23RD MAY 1884, No. 1297 W., PUBLIC WORKS.

Christ Church, Cuddapah

Stating that it is not possible to make any grant of funds for the erection of a belfry for —, and that the question as to departure from the original design for the church will be remitted to Mr. Chisholm on his return from leave.

Plan of Belfry
to the
Church at Cuddapah

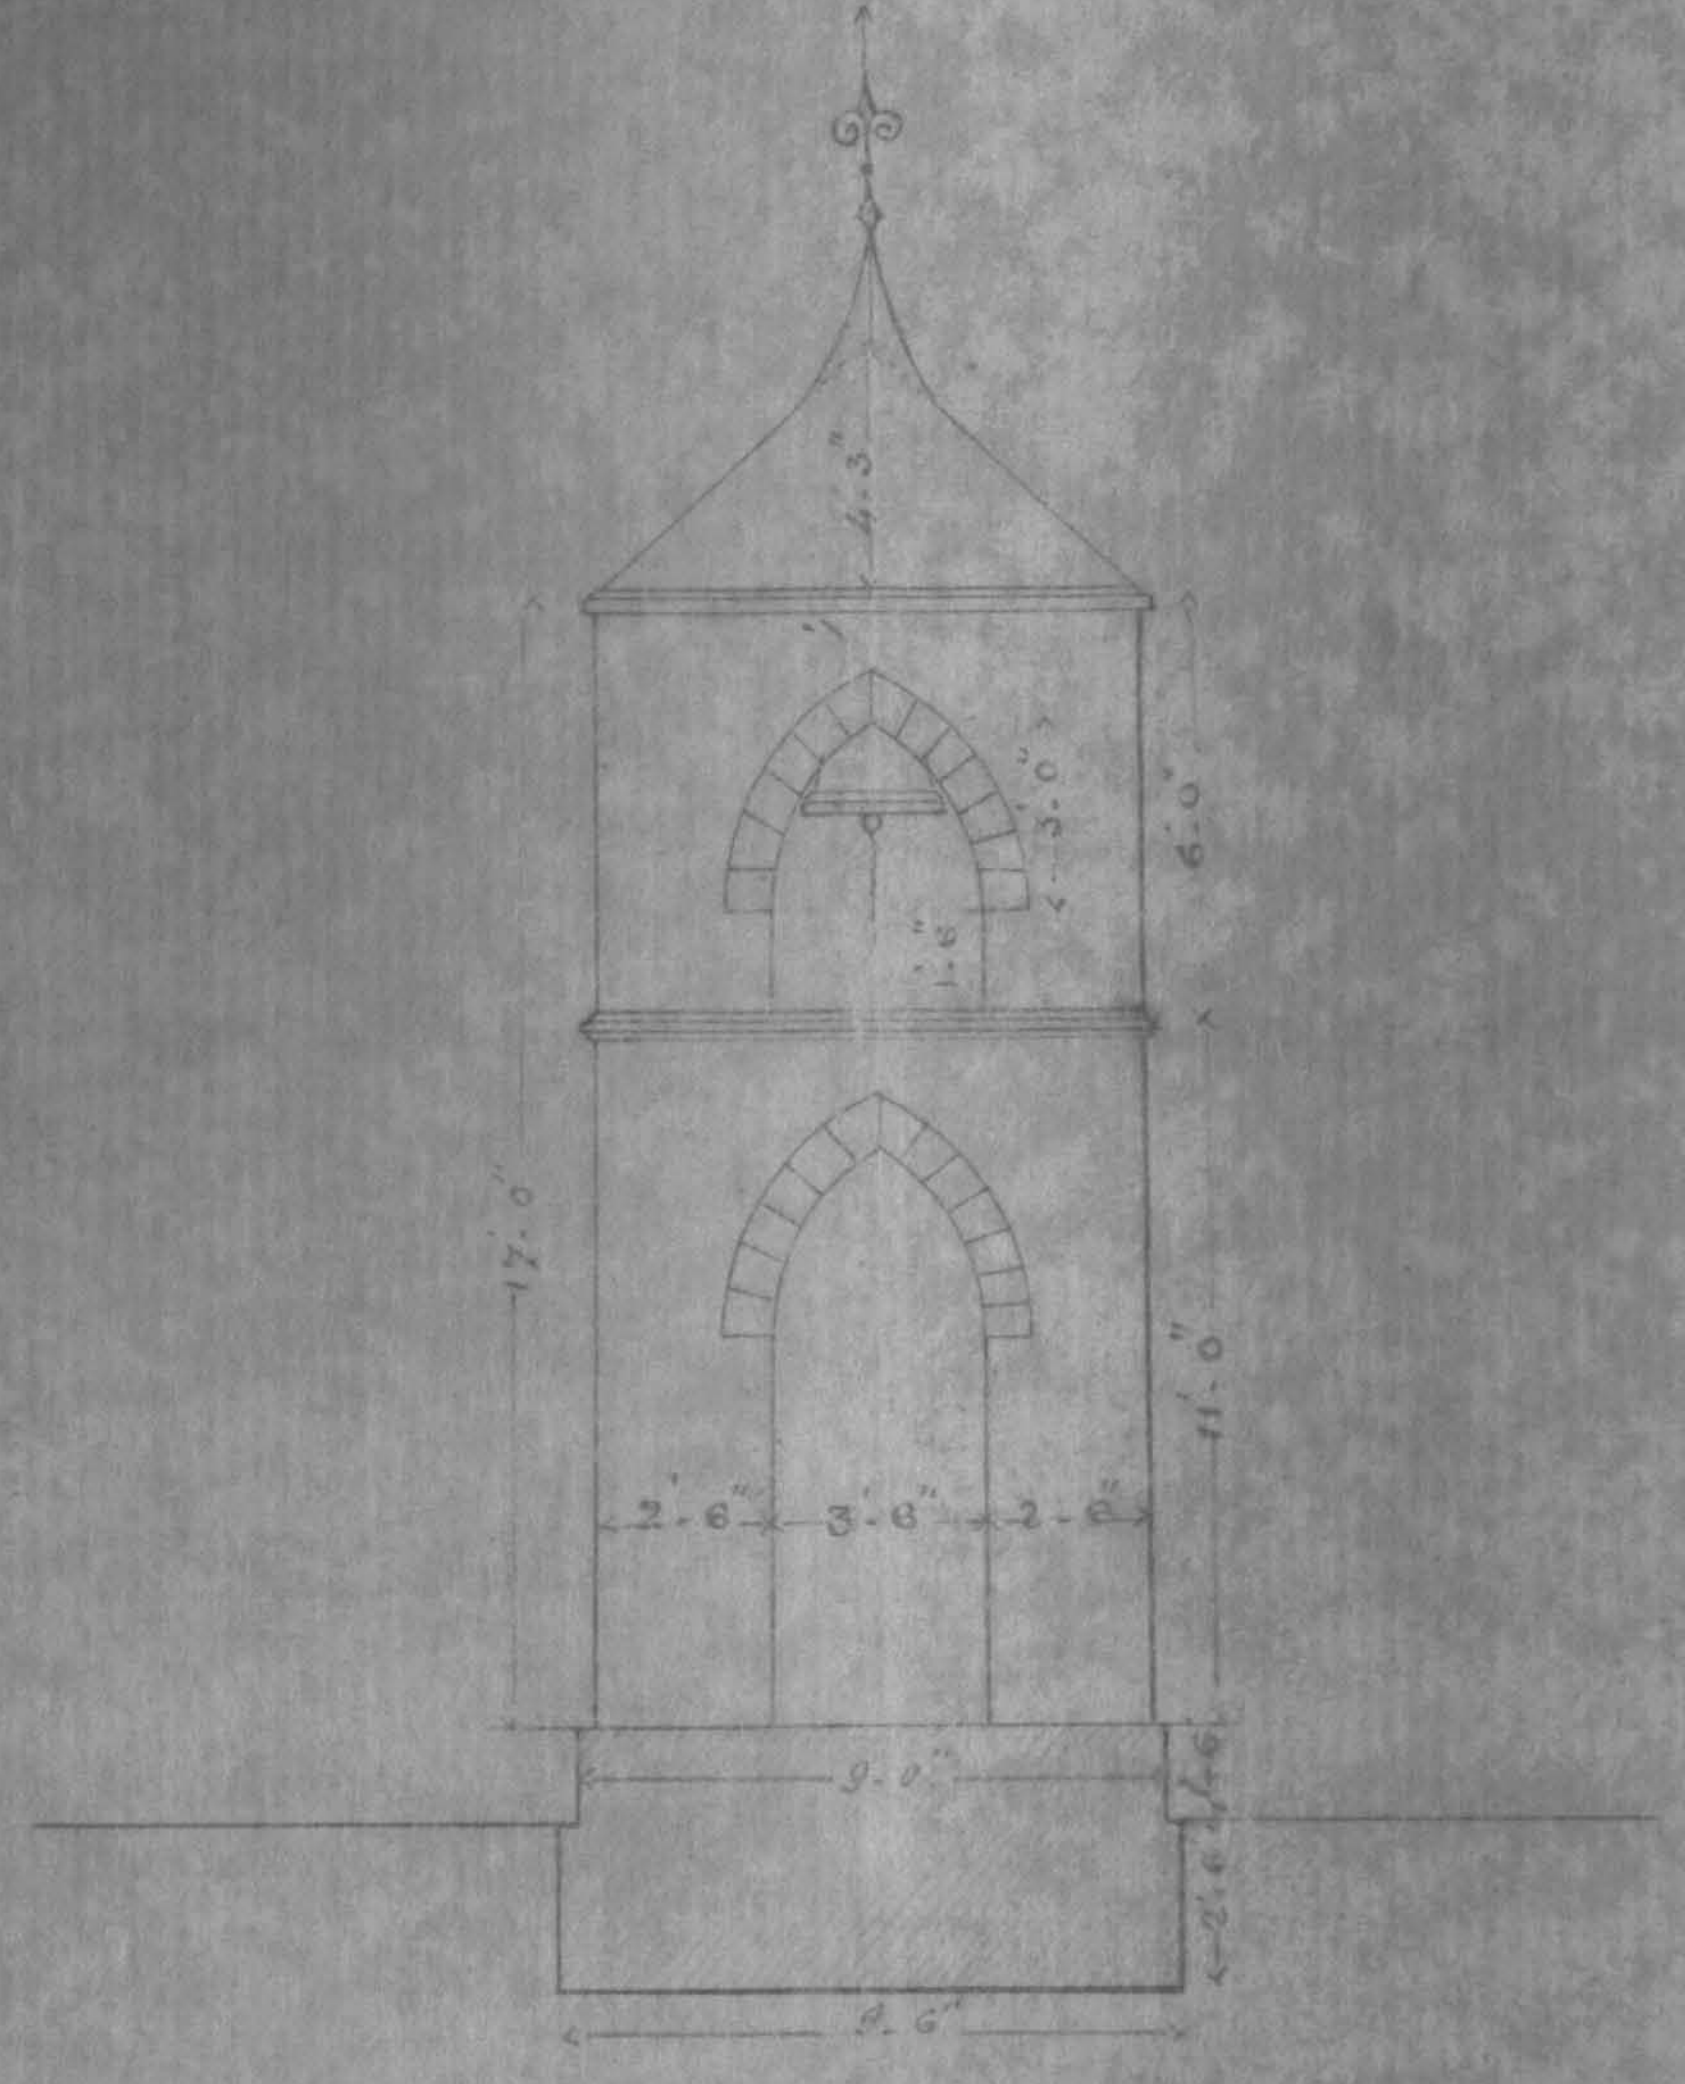
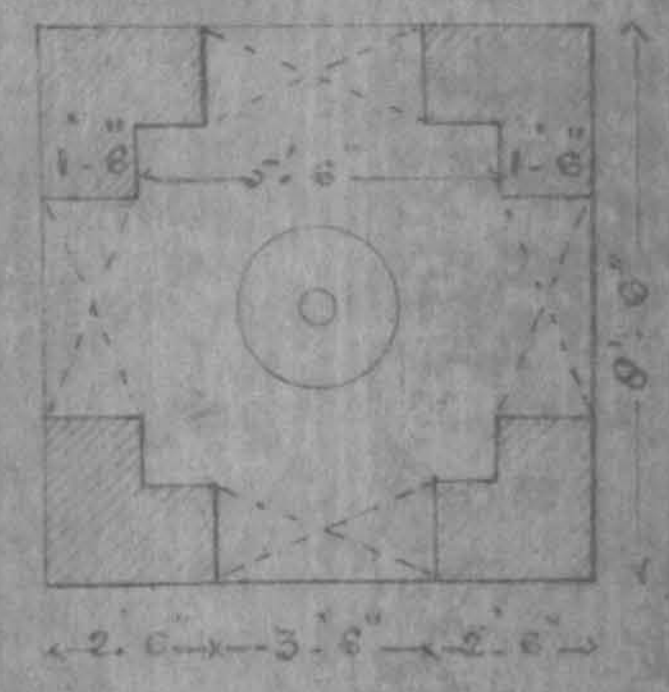
1. The accompanying plan and estimate provide for the erection of a belfry to Christ Church, Cuddapah. The estimated cost is Rs. 718. The design is submitted in compliance with G.O. No. 1921 W of the 9th July/83.

2. The design is well suited to the style of the church, and the C. A. draws attention to the fact that the tower may be built either in connection with, or free from the church. The position shown on plan appears well chosen for the tower.

2 It should be noted that the cost of the proposed belfry has been increased from Rs 253 to Rs 718, and the question whether the Church fund can meet the expenditure requires consideration
